PLANS OF PROPOSED MIDWAY DRIVE PICARDY AVENUE TO CONSTANTIN BLVD CITY PARISH PROJECT No. 20-CP-HC-0008

**SUMMARY OF ESTIMATED QUANTITIES**

**CHANGE ORDER AND/OR SPECIAL AGREEMENT**

SHEET NUMBER 18A

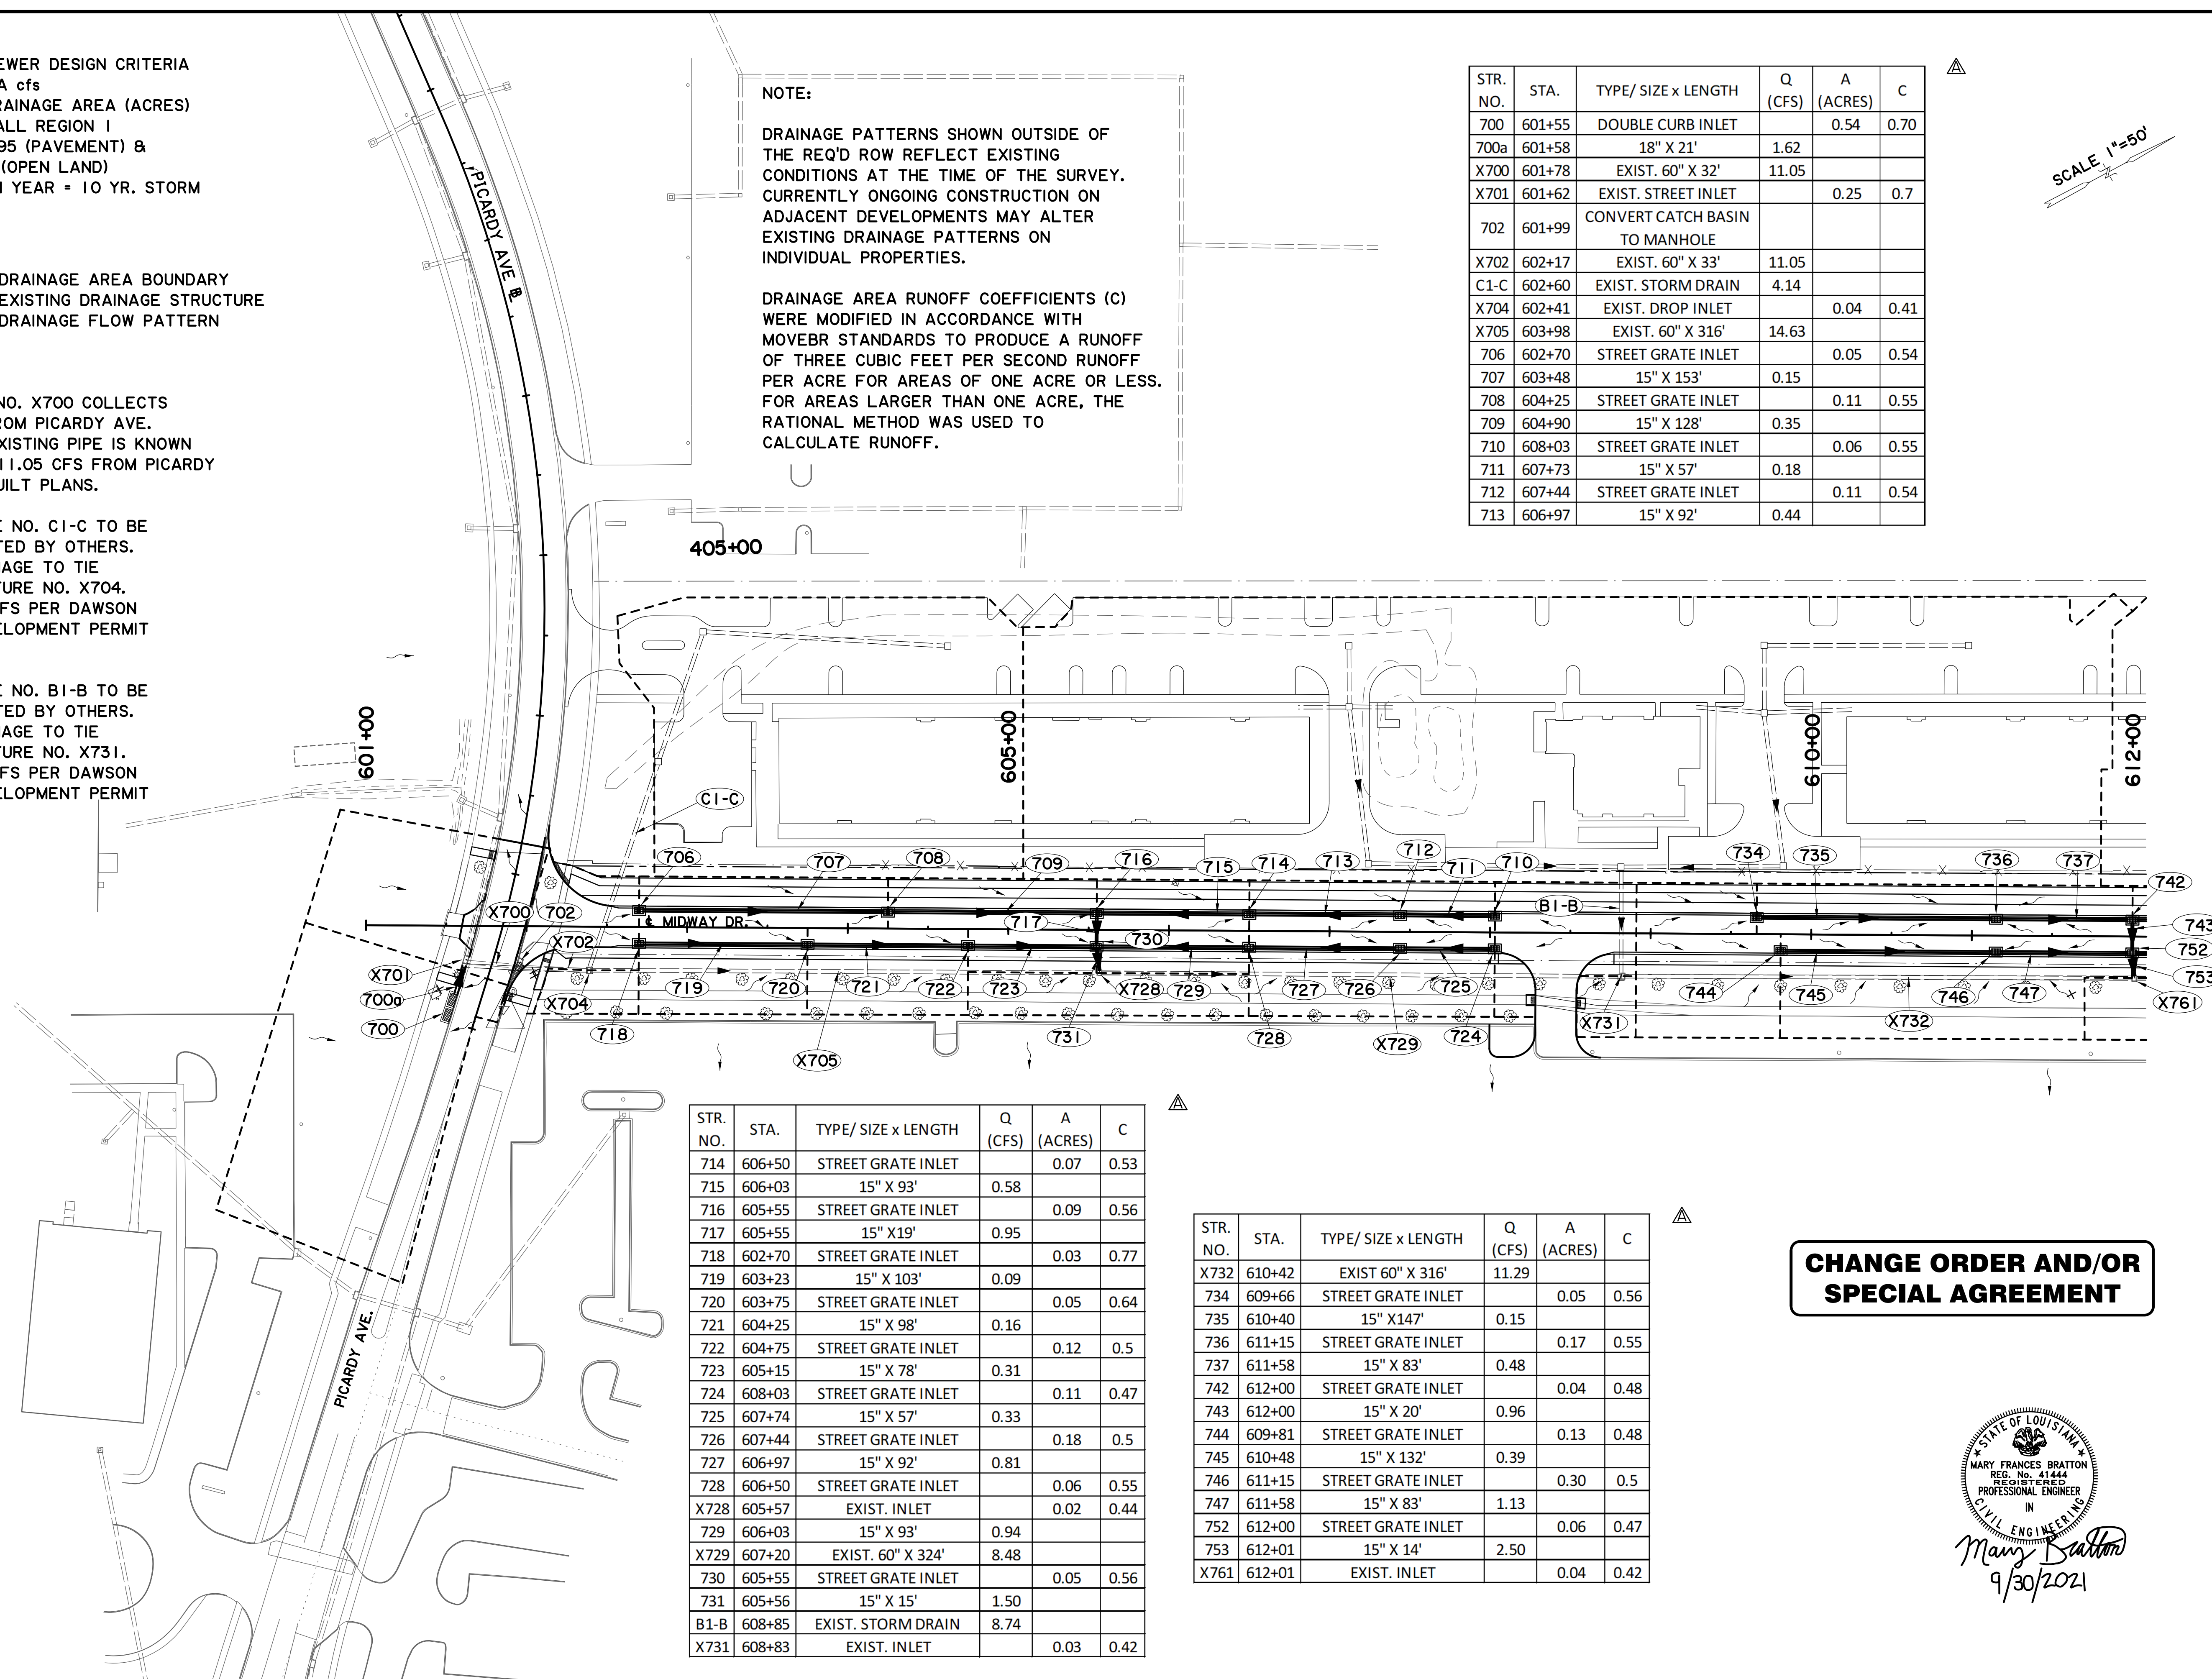
NO.	DATE	REVISION DESCRIPTION	BY
1	5-17-22	REVISED PIPE SIZE & MATERIAL

SHEET NUMBER 19A

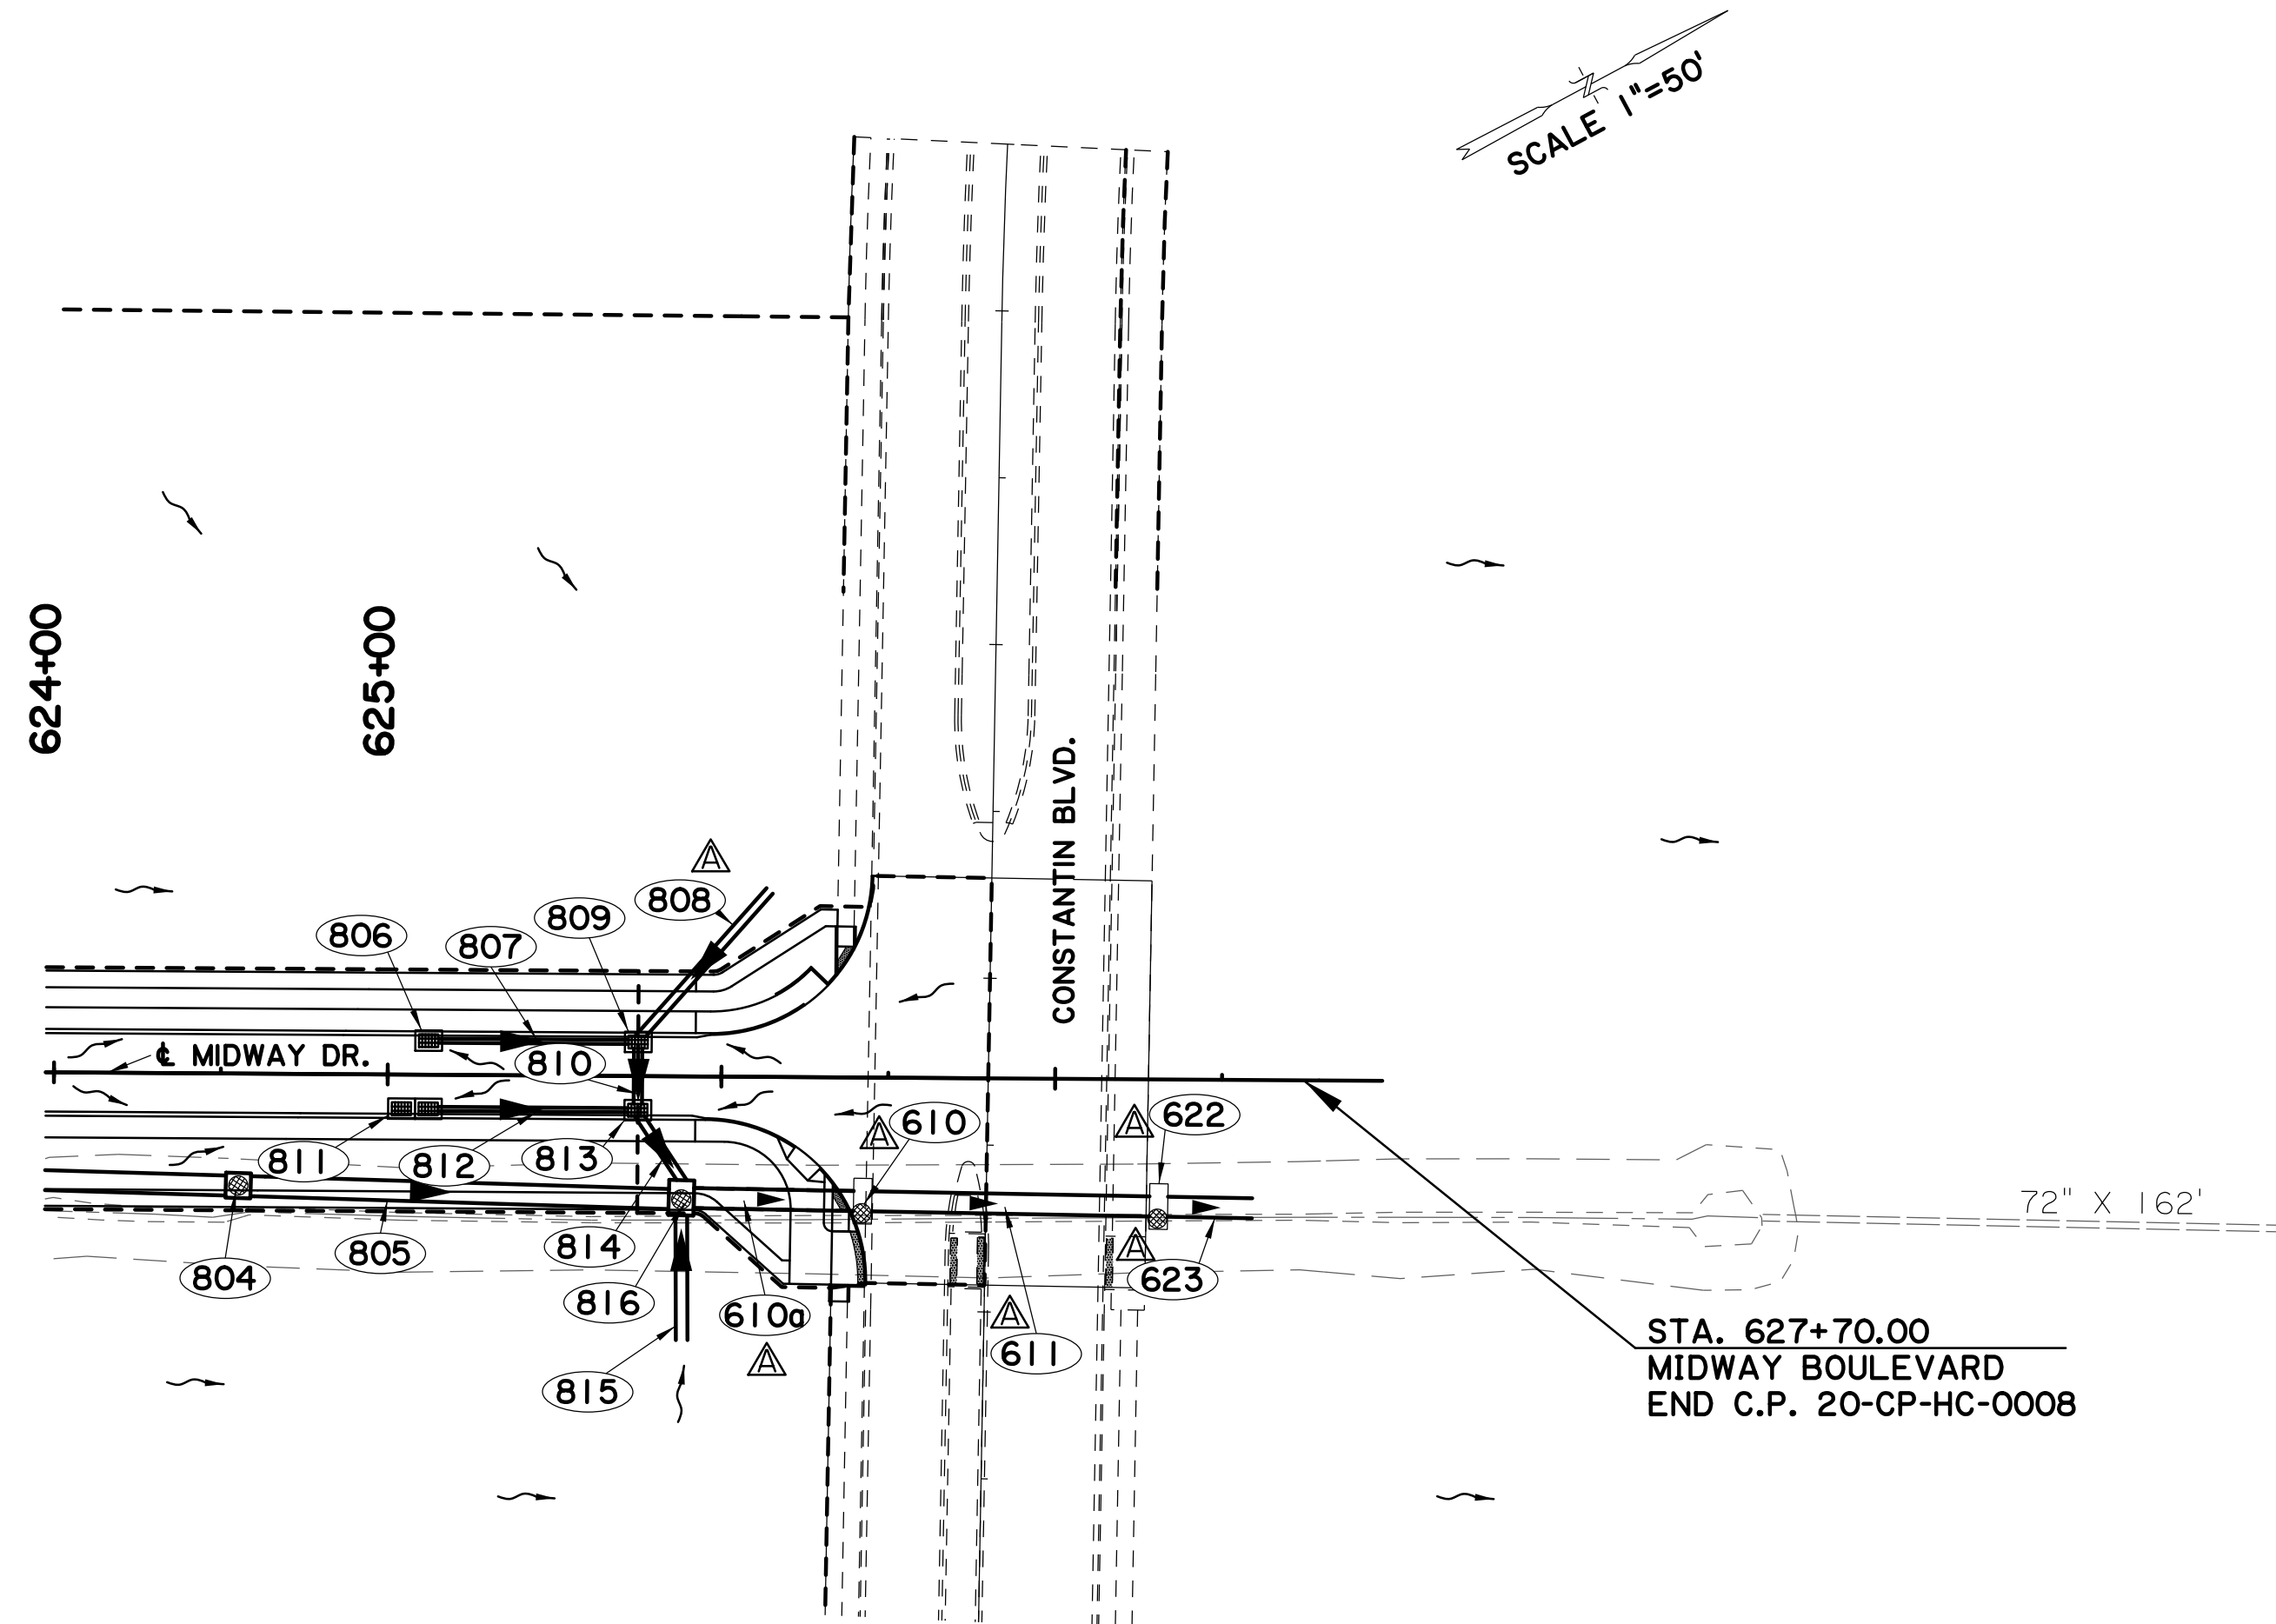
5-17-22 ADDED DROP INLET AND PIPE; UPDATED QAC TABLES

SHEET NUMBER	31A
PARISH	EAST BATON ROUGE PARISH
CITY PROJECT	20-CP-HC-0008
STATE PROJECT	-
DESIGNED	NDP
CHECKED	AMR
DATE	4 OF 8
REVISION NO.	5-17-22
REVISION DESCRIPTION	REVISED INVERTS & PIPE SIZE; ADDED DROP LINE; UPDATED EXIST. GROUND
BY	NICHOLAS D. PRUDHOMME
DATE	9/30/2021

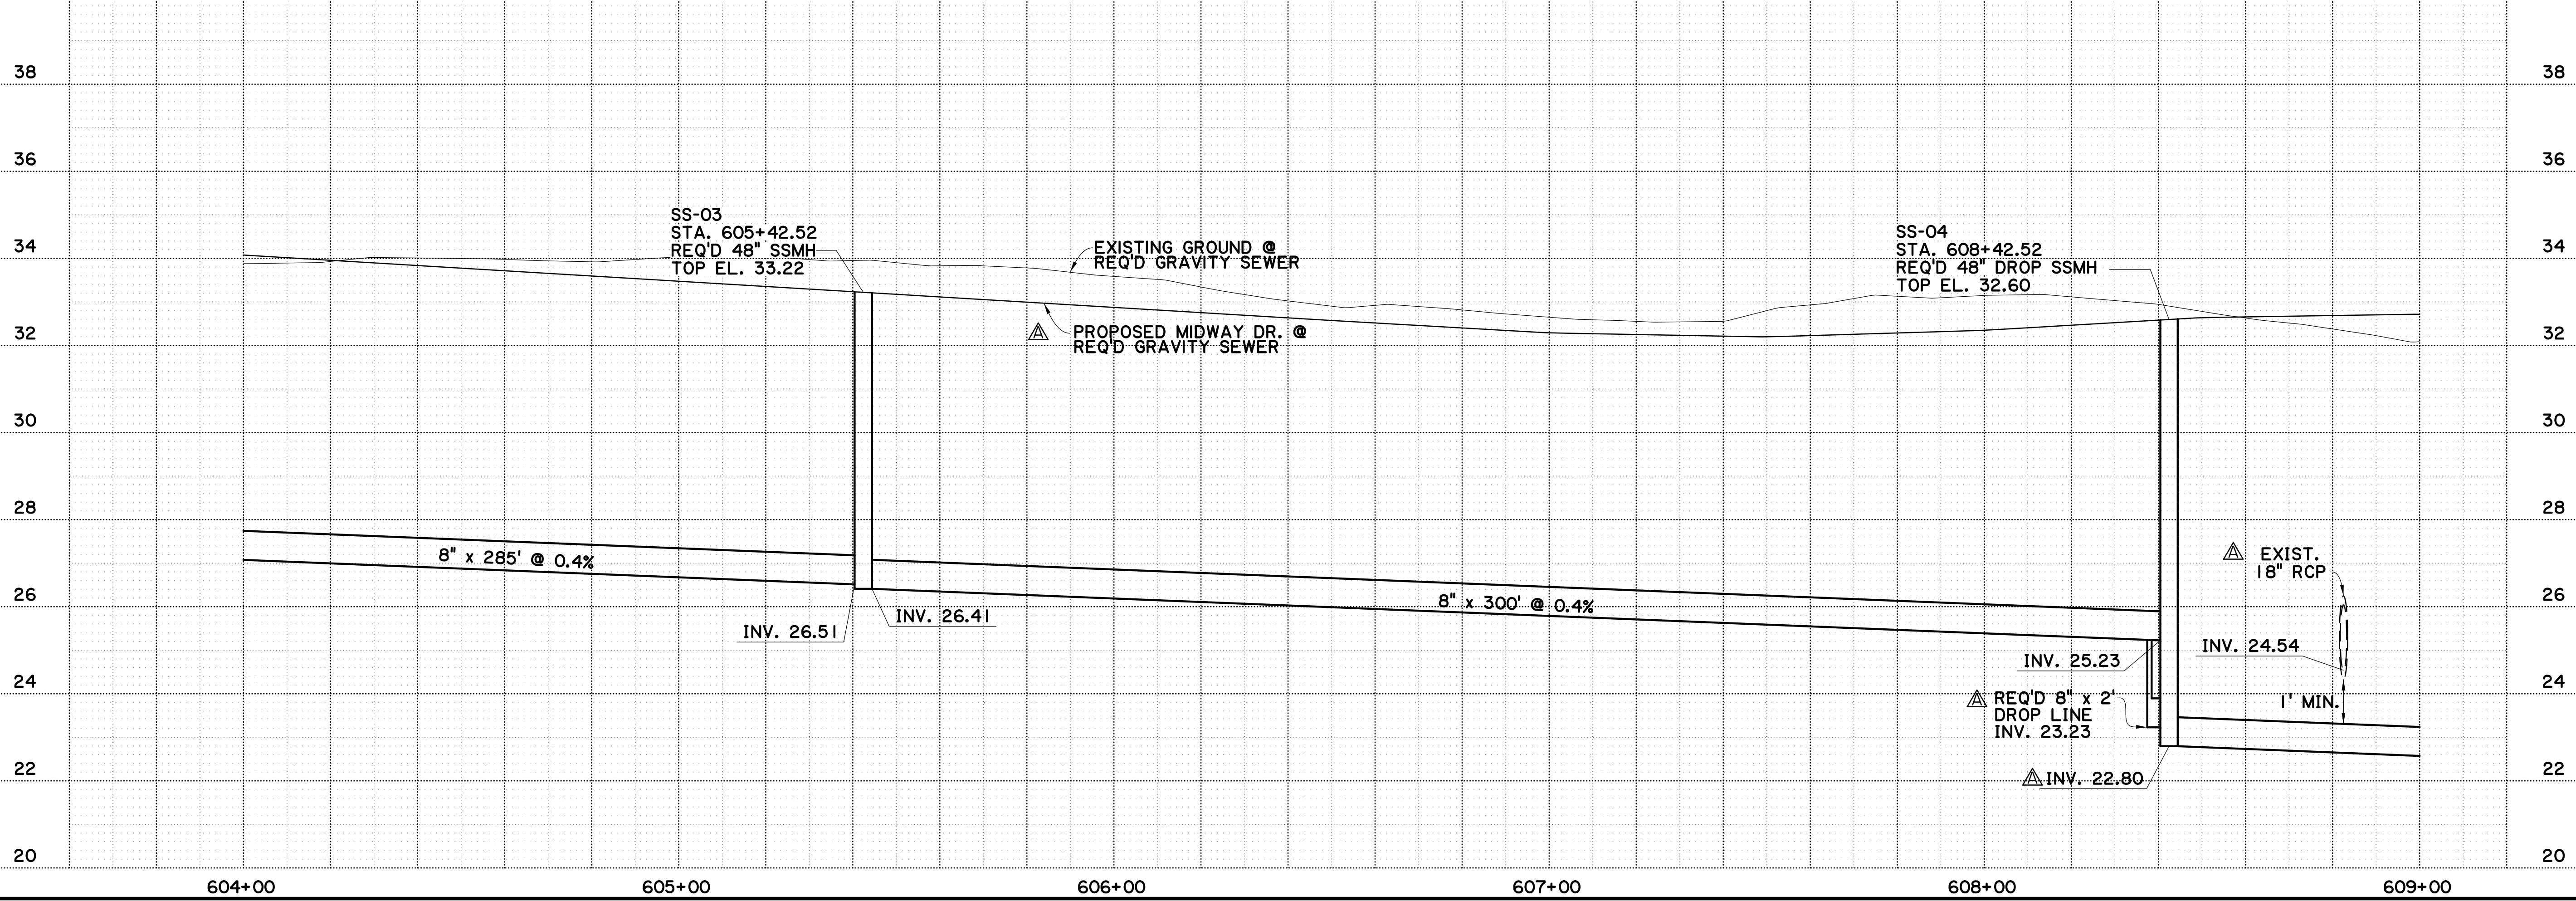
DESIGNED	NDP	5-17-22	REVISIED INVERTS; UPDATED EXIST. GROUND LINE
CHECKED	AMR		
DATE			
NO.			
BY			
REVISION DESCRIPTION
